Tree Permit

Planning and Development Review Department

ROW I.D. 10392097

Address of Property (including zip code): 409 E. 5th St.

PLAN

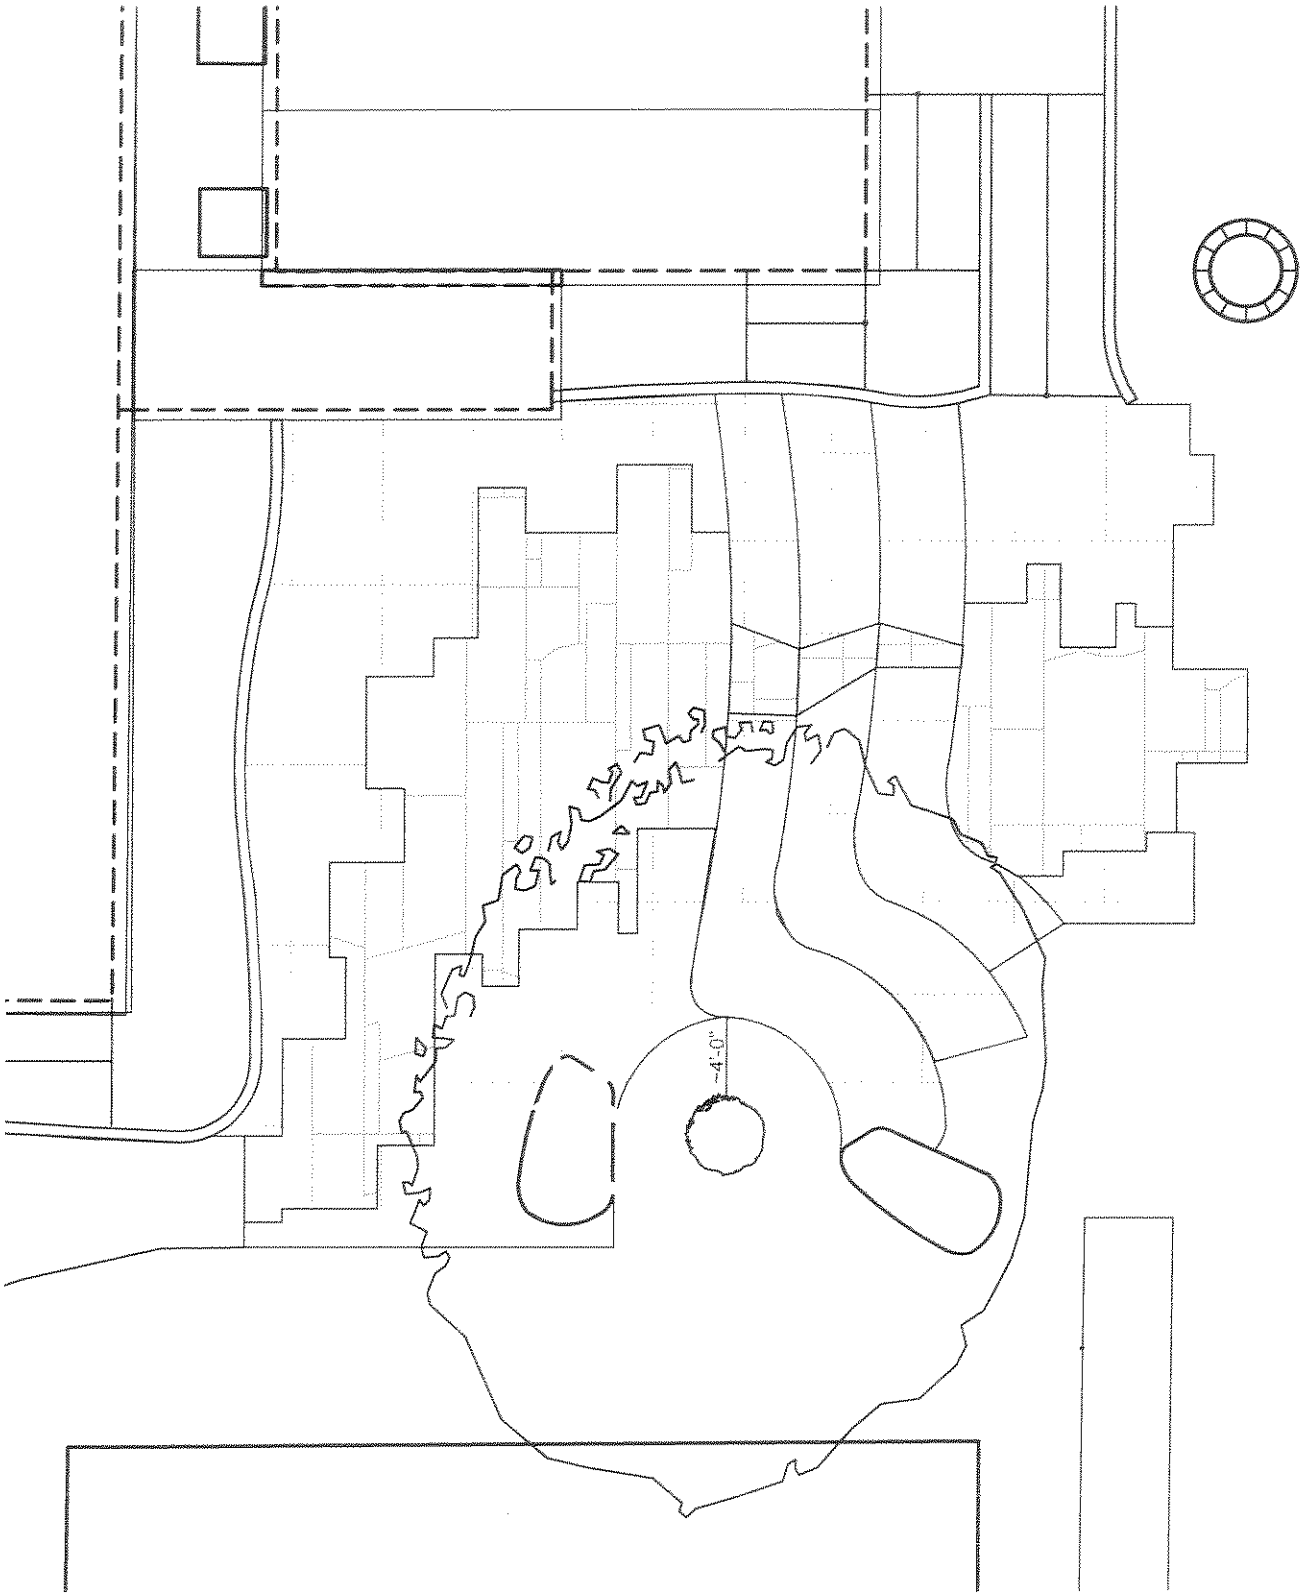
Comments: THANK YOU FOR REMOVING THE HISTORICAL COMPACTED PARKING ALLEYS NEAR THE TREE, AND FOR PERFORMING NUMEROUS PRE-CONSTRUCTION ASSISTANCE TO THE TREE'S ROOT SYSTEM.

☒ Prior to development, applicant agrees to supply an 8-inch root zone mulch layer and maintain tree protection fencing (chain-link, five-foot in height) throughout the project duration.

☒ No impacts are permitted within the tree 1/2 critical root zone (* ECM 3.5.2), including trenching for utilities.
